E5061B-11

S E R V I C E N O T E

E5061B ENA Series Network Analyzer

E5061B LCD Touch Panel Display Assembly Replacement Part Change

Figure 1-1

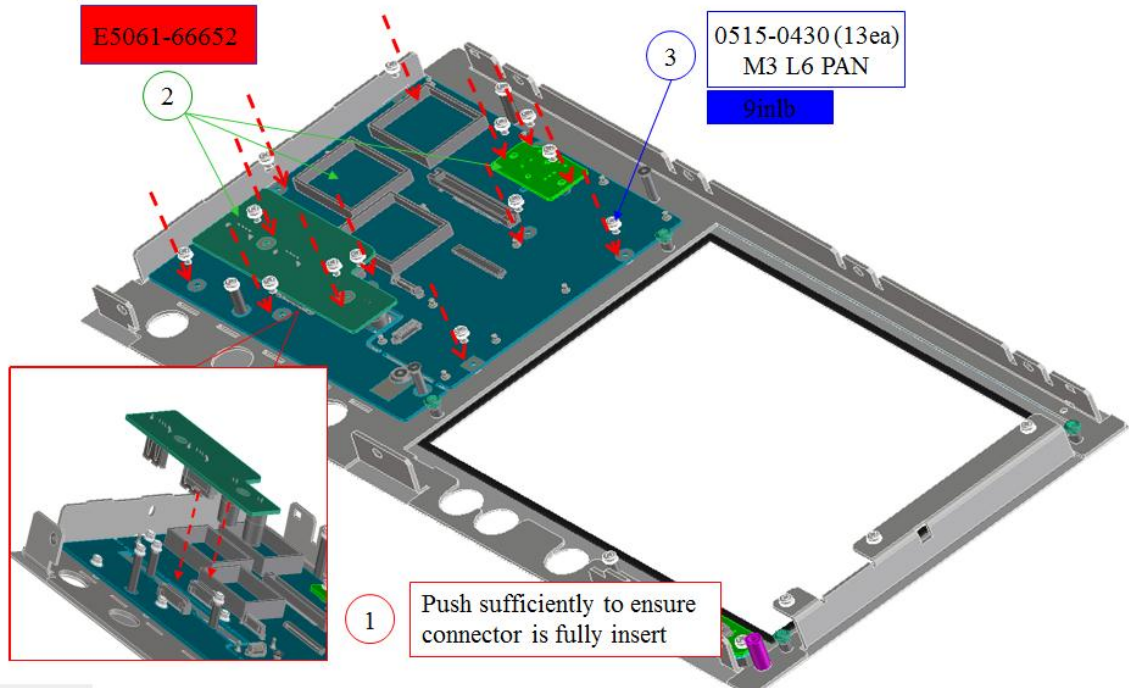
1. Reuse and install the keyboard, keyboard PCA and power switch PCA on the new front panel sub as shown in figure 1-1.

Note: The front panel, panel sub and cover shield are required to be replaced due to dimension changes. Front panel frequency label has to be purchased separately according to unit frequency options.

Figure 1-2

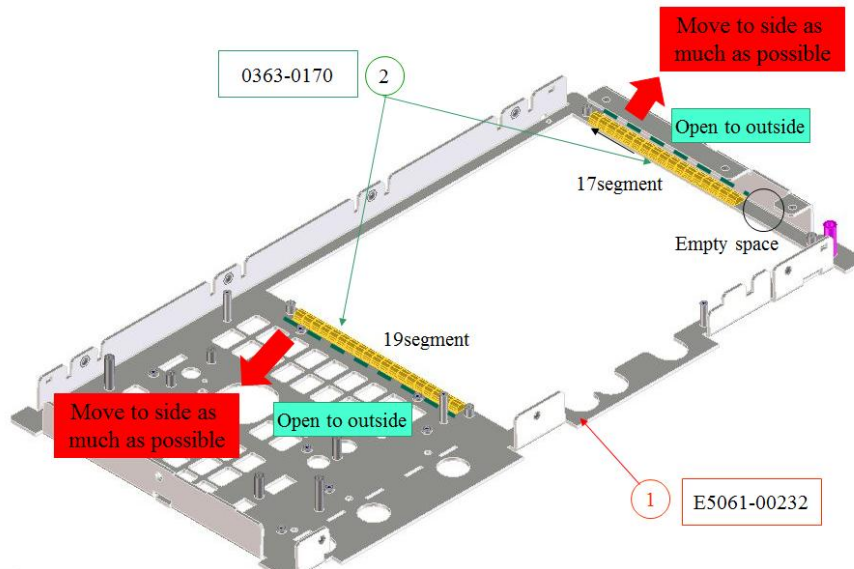
2. Install the gaskets as shown in Figure 1-2. Figure 1-3 illustrates the Front panel with the keyboard installed.

Figure 1-4

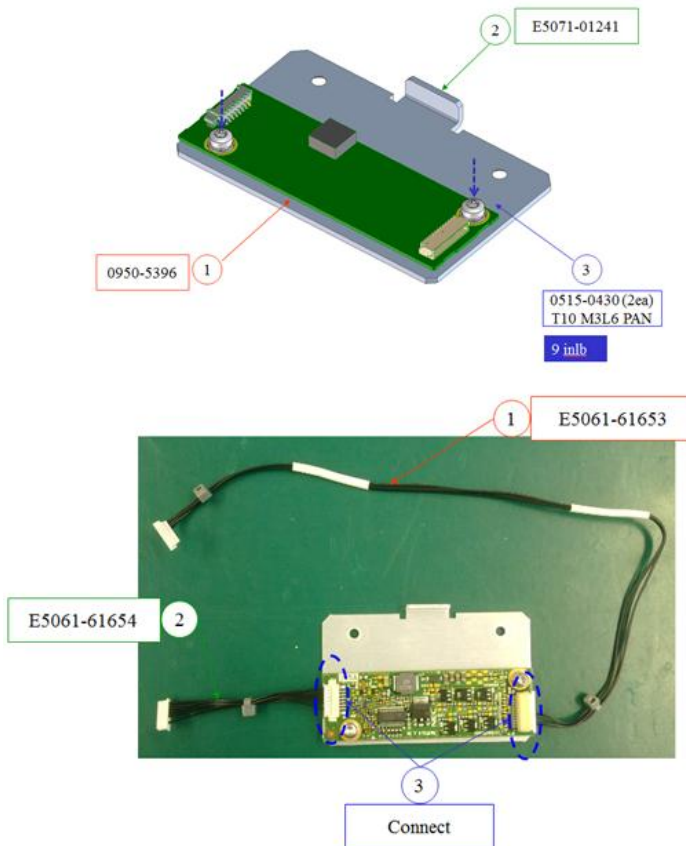
3. Install the inverter on the bracket before connect the cable assembly to both ends as shown in figure 1-4

Figure 1-7

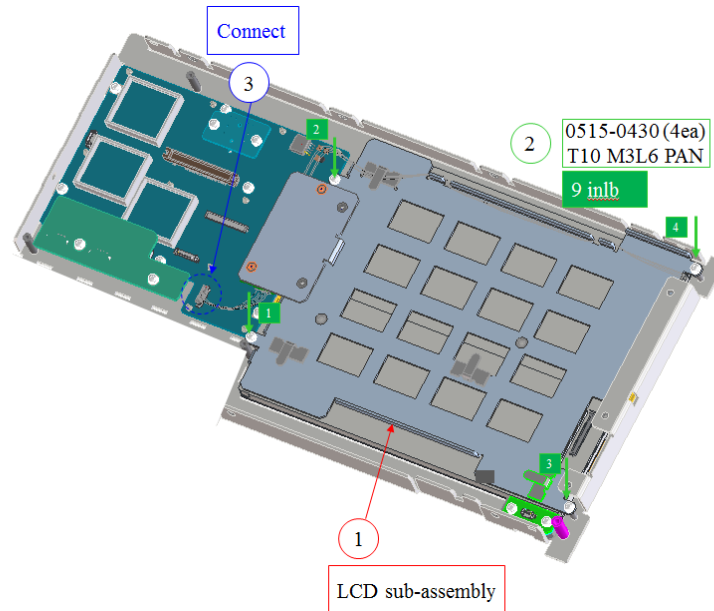
6. Install the LCD T/P Display Assembly onto the LCD Front Panel. Fasten the screws according to the following sequence. Connect all cable assemblies as shown in figure 1-7.

Figure 1-8

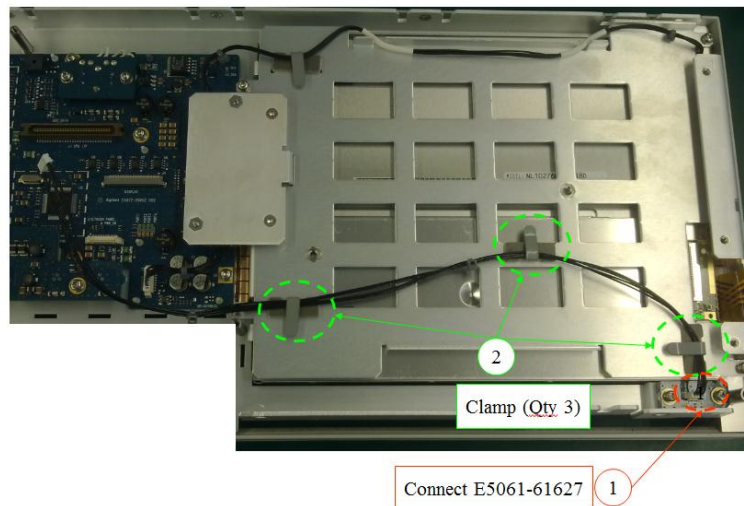
7. Connect, route and clamp the power switch cable assembly as shown in figure 1-8

Figure 1-9

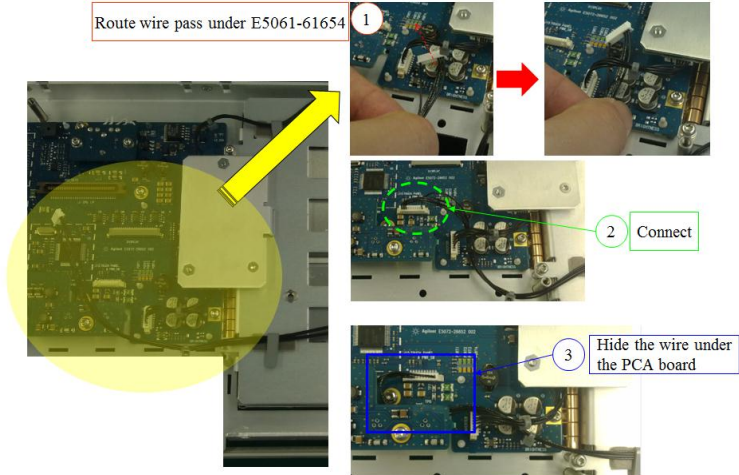
- 8. Connect the cable assemblies to the keyboard PCA as shown in figure 1-9.

Figure 1-10

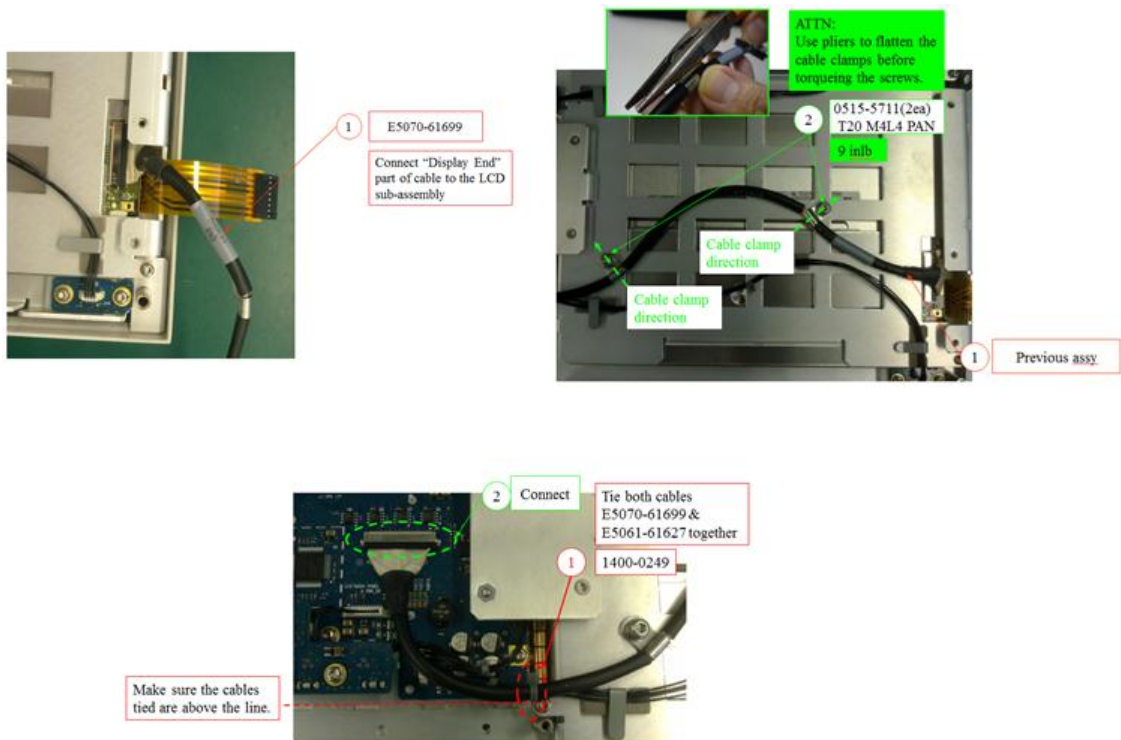
- 9. Connect the LCD T/P display cable assembly as shown. Fasten the screws in securing the cable. Tie the LCD T/P Display cable assembly to the Power switch cable assembly as shown in figure 1-10.

Figure 1-11

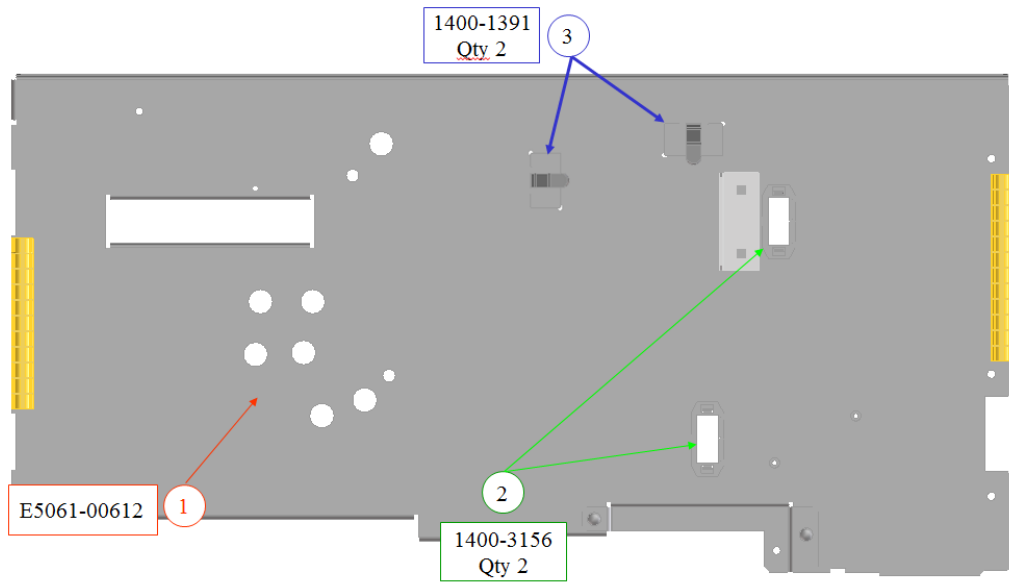
- 10. On the Front Panel back cover shield, install the cable clamp as shown in figure 1-11

Figure 1-12

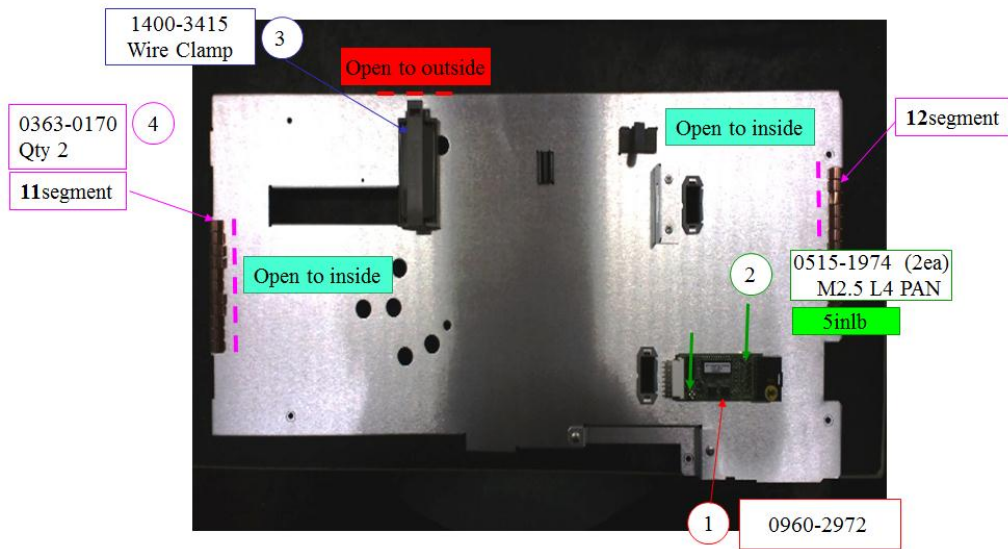
11. Install the cable clamps and Gasket (RFI fins) on the back cover as shown in figure 1-12.

Figure 1-14

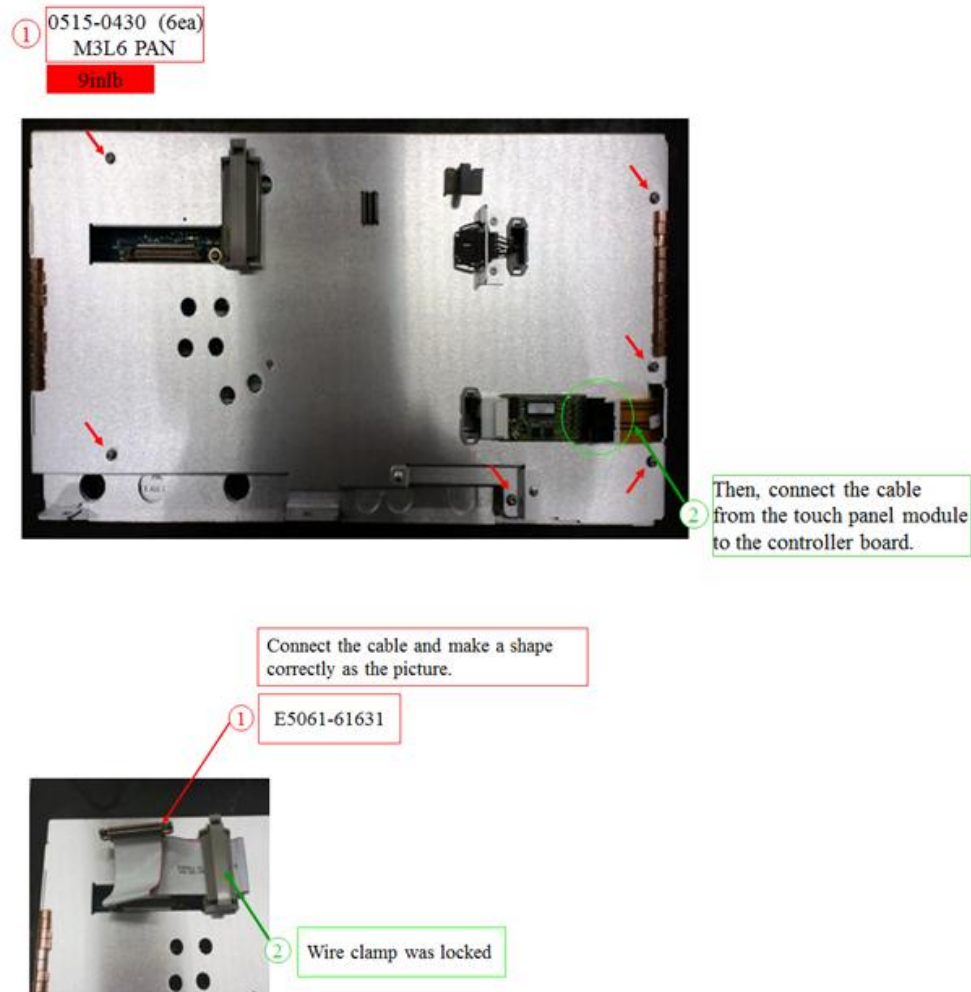
13. Shown would be the completed installation of the assemblies. Kindly ensure the connections of the cable assemblies are good and properly secured. Fasten the six screws in securing the shield (back cover) to the Front Panel Assembly. Refer to figure 1-14 for details.

Figure 2-1

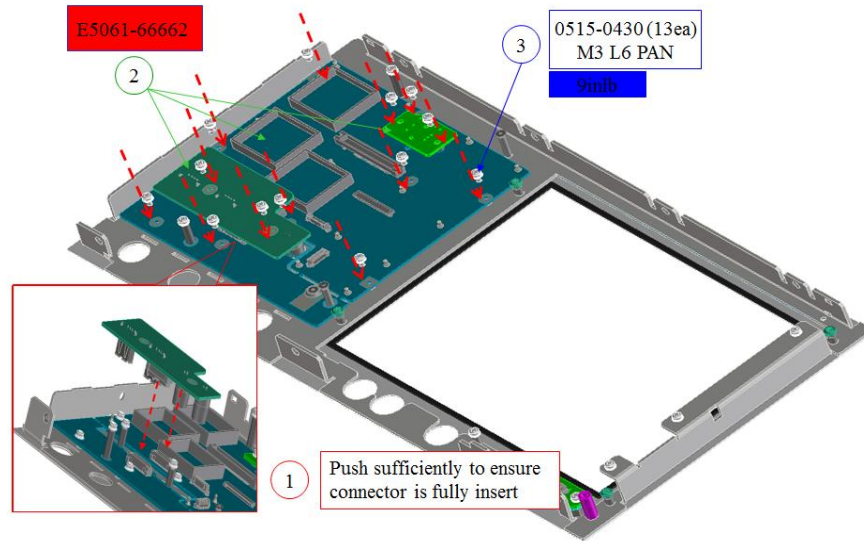
1. Reuse and install the keyboard, keyboard PCA and power switch PCA on the new front panel sub as shown in figure 2-1.

Note: The front panel, panel sub and cover shield are required to be replaced due to dimension changes. Front panel frequency label has to be purchased separately according to unit frequency options.

Figure 2-2

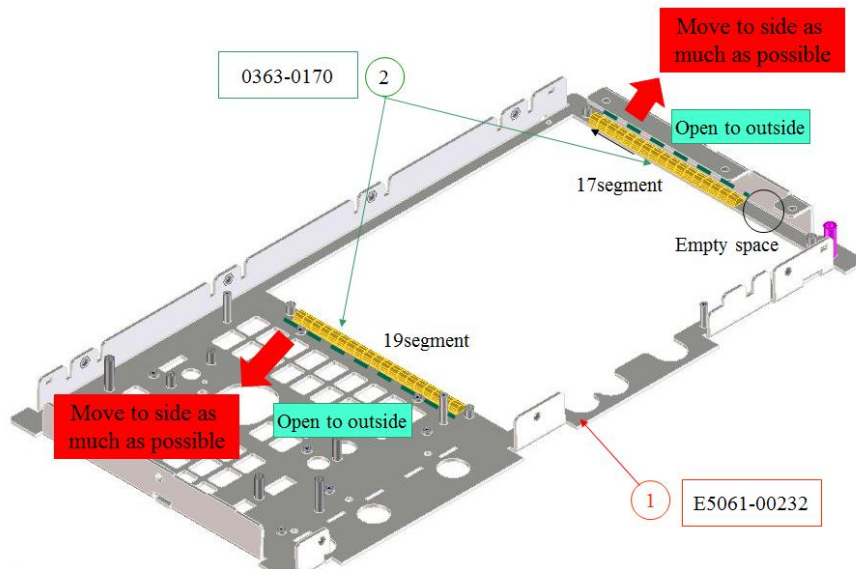
2. Install the gaskets as shown in Figure 2-2. Figure 2-3 illustrates the Front panel with the keyboard installed.

Figure 2-4

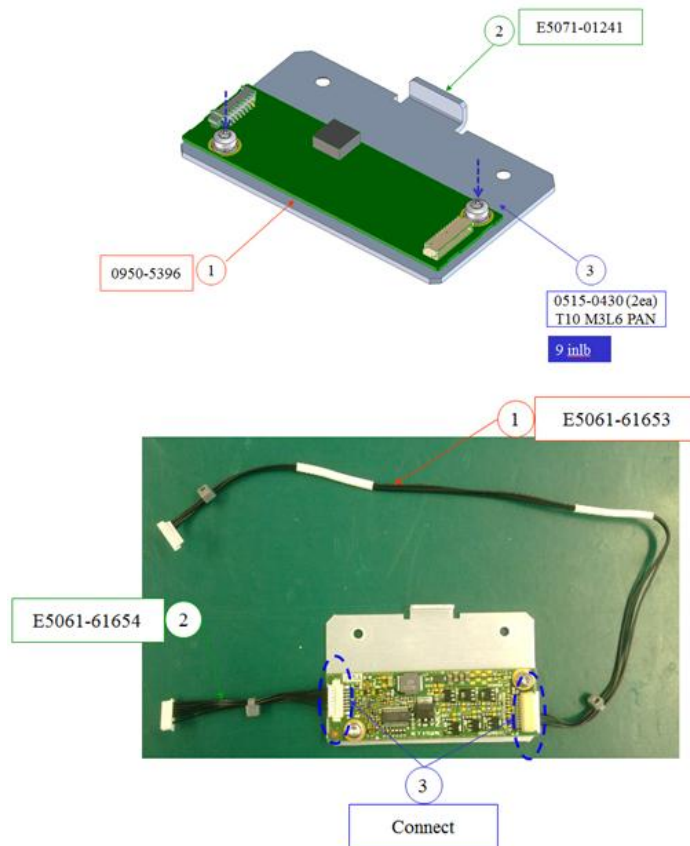
3. Install the inverter on the bracket before connect the cable assembly to both ends as shown in figure 2-4

Figure 2-5

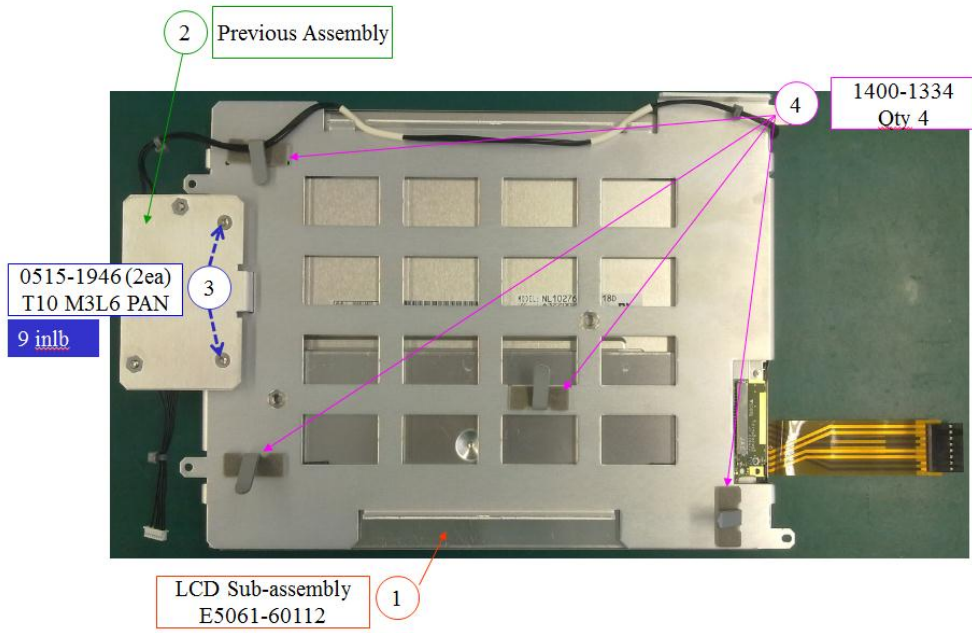
4. Install the inverter assembly onto the new LCD T/P display assembly (with LED backlight). Refer to figure 2-5 for details.

Figure 2-6

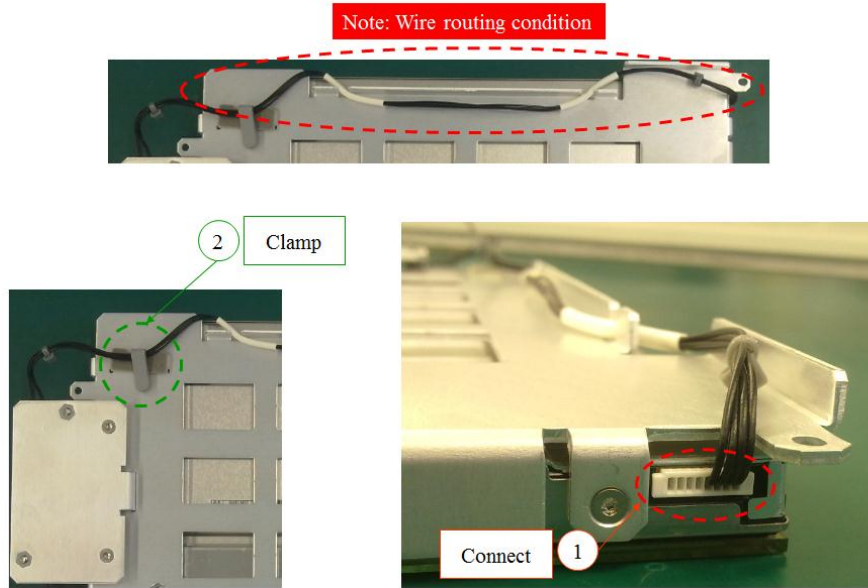
5. Connect and route the LCD display assembly cables accordingly.

Figure 2-7

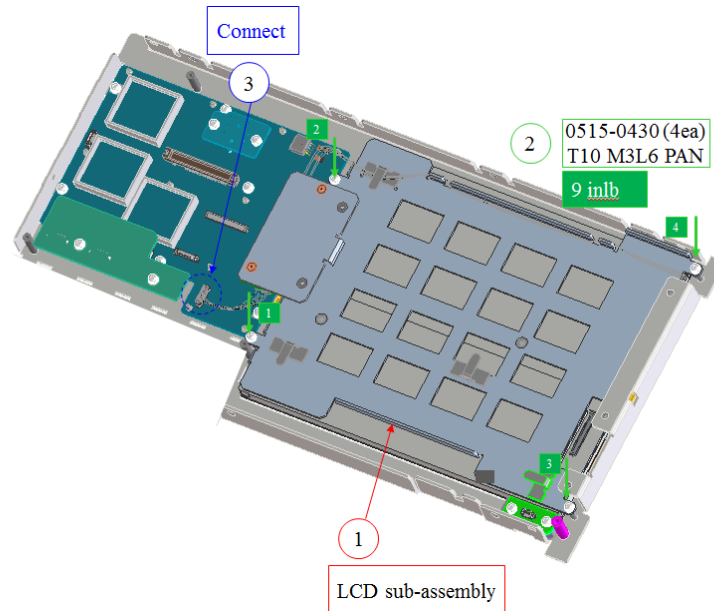
6. Install the LCD T/P Display Assembly onto the LCD Front Panel. Fasten the screws according to the following sequence. Connect all cable assemblies as shown in figure 2-7.

Figure 2-8

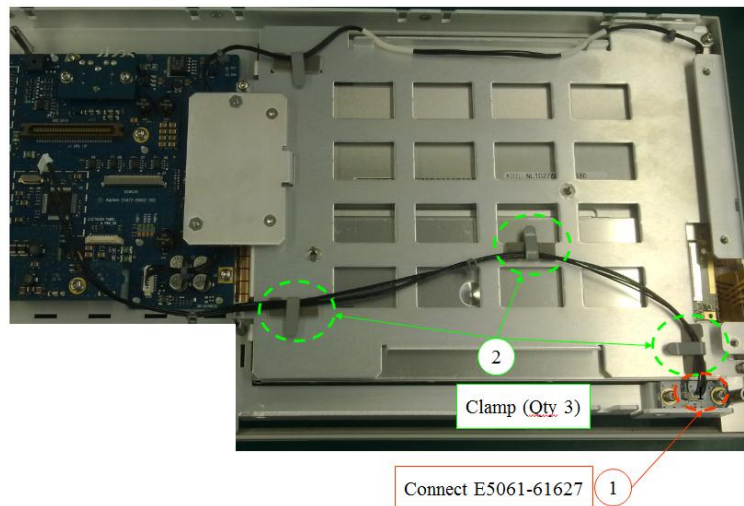
7. Connect, route and clamp the power switch cable assembly as shown in figure 2-8

Figure 2-9

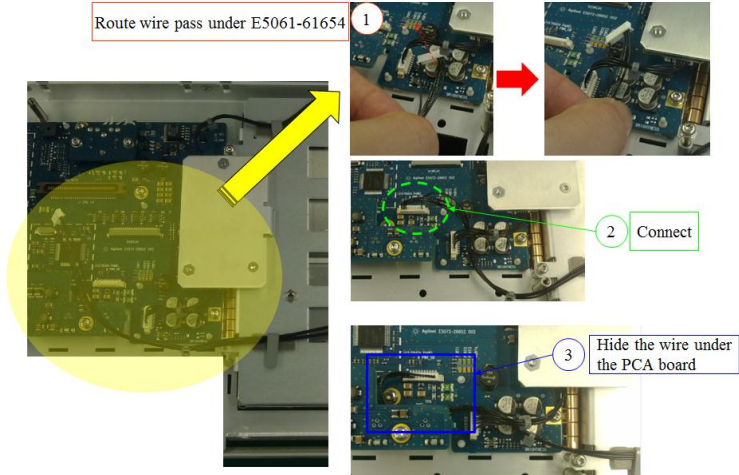
- 8. Connect the cable assemblies to the keyboard PCA as shown in figure 2-9.

Figure 2-10

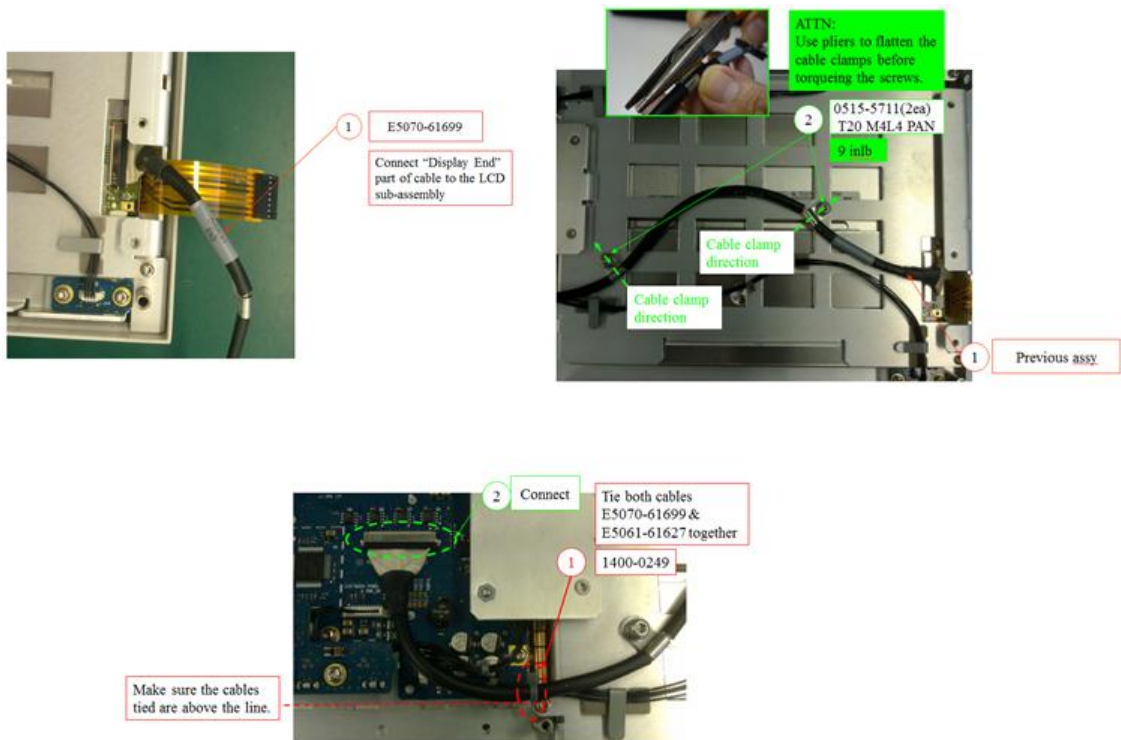
- 9. Connect the LCD T/P display cable assembly as shown. Fasten the screws in securing the cable. Tie the LCD T/P Display cable assembly to the Power switch cable assembly as shown in figure 2-10.
